**DEFENSE NUCLEAR FACILITIES
SAFETY BOARD**

Staff Report

Device Assembly Facility Seismic Hazard

Figure 1 – Comparison of horizontal and vertical response spectra derived from [3] and [4].

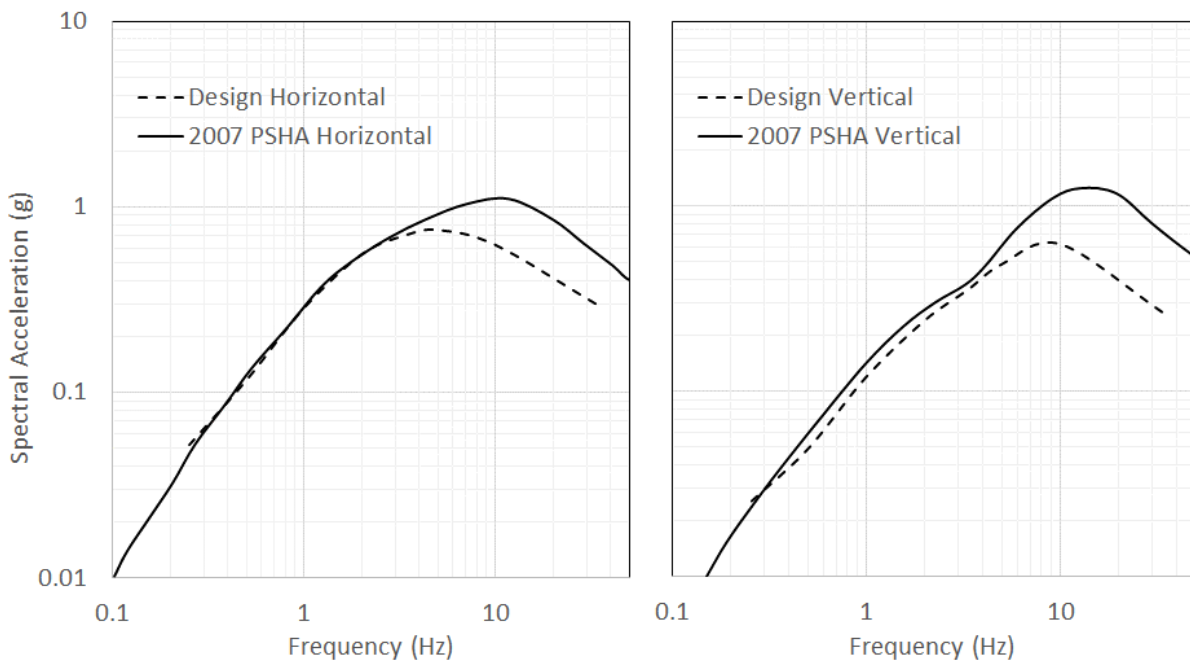
Background. As part of the 10-year assessment of the seismic hazard, the previous site contractor, National Security Technologies, LLC (NSTec), analyzed the seismic hazard for DAF in 2007 using a probabilistic seismic hazard analysis (PSHA) approach. In the 2007 PSHA [3], the ground motion response spectra significantly exceeded the previous 1995 analysis [4] for the design-basis earthquake response spectra in a sensitive frequency range for safety-related structures, systems, and components (SSCs). Safety-related SSCs are generally sensitive to ground motion between 1 and 10 Hz. The horizontal ground motion spectrum in the 2007 PSHA exceeds the horizontal seismic design spectrum at 3 Hz and above. The vertical spectrum in the 2007 PSHA also exceeds the corresponding design spectrum for the same frequency range. A comparison between the 2007 PSHA and design basis response spectra is provided in Figure 1.
